ZS-2010-0329

Zion Nuclear Power Station, Units 1 and 2
Facility Operating License Nos. DPR-39 and DPR-48
NRC Docket Nos. 50-295 and 50-304

Subject: Submittal of Defueled Safety Analysis Report Update, Revision 6
Report of Changes, Tests and Experiments

**ZION NUCLEAR POWER STATION
DEFUELED SAFETY ANALYSIS REPORT REVISION 6**

ZION STATION DSAR
 Figure 3-41
Auxiliary Building Ventilation Supply System
 (SIMPLIFIED) October 2010

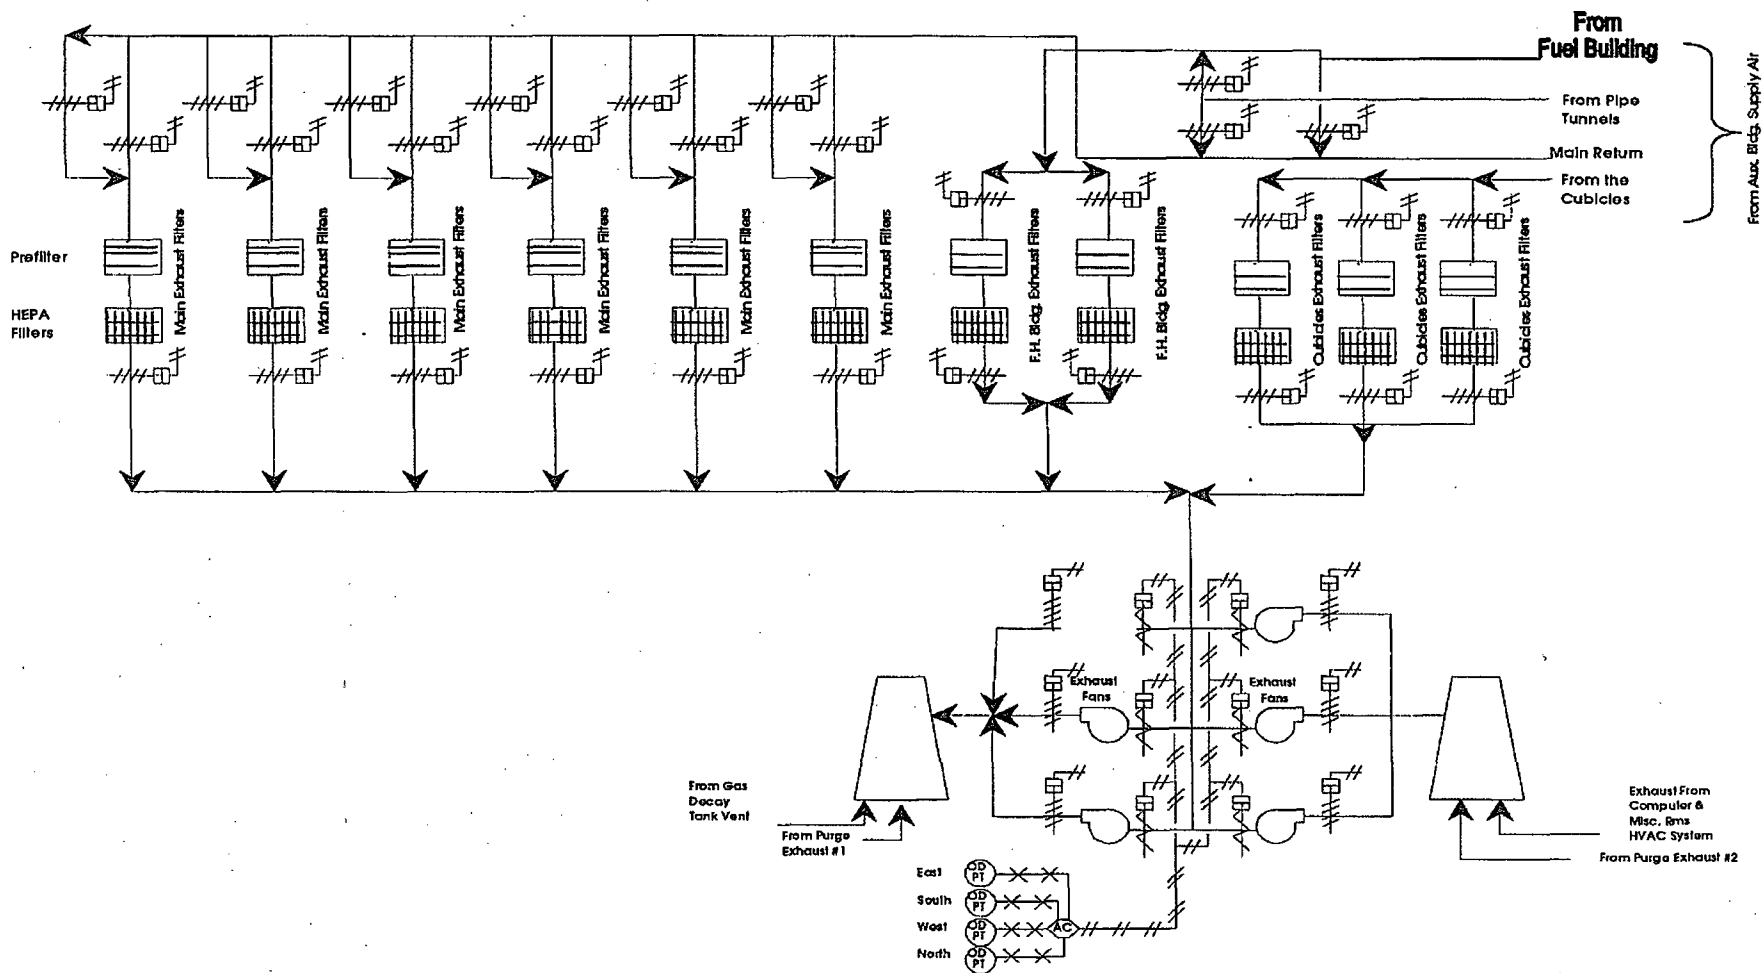
Pages	Description of Change
Page 3-55, Figure 3-45	Delete references to Unit 2 Main Power Transformers and Unit Auxiliary Transformer which have been physically removed.
Pages, 3-50, 3-52a, 3-60, 4-13, Figures 3-41, 3-42, 3-42A, Table 4-3	Eliminate discussion of Fuel Building ventilation system and associated effluent radiation monitors since the Fuel Building has been reconnected to the Auxiliary Building ventilation system.
Page 3-47, Figure 3-40	Revise system description to reflect Service Water Booster Pump supply isolation to traveling screens and copper injection system.
Pages 1-1, 1-4, 1-5, 1-6, 1-9, 2-1, 3-4, 4- 1, 4-3, 4-5, 6-1, 6-4, 6-5	Update document to reflect license transfer from Exelon Generation Company (EGC) to Zion Solutions (ZS).
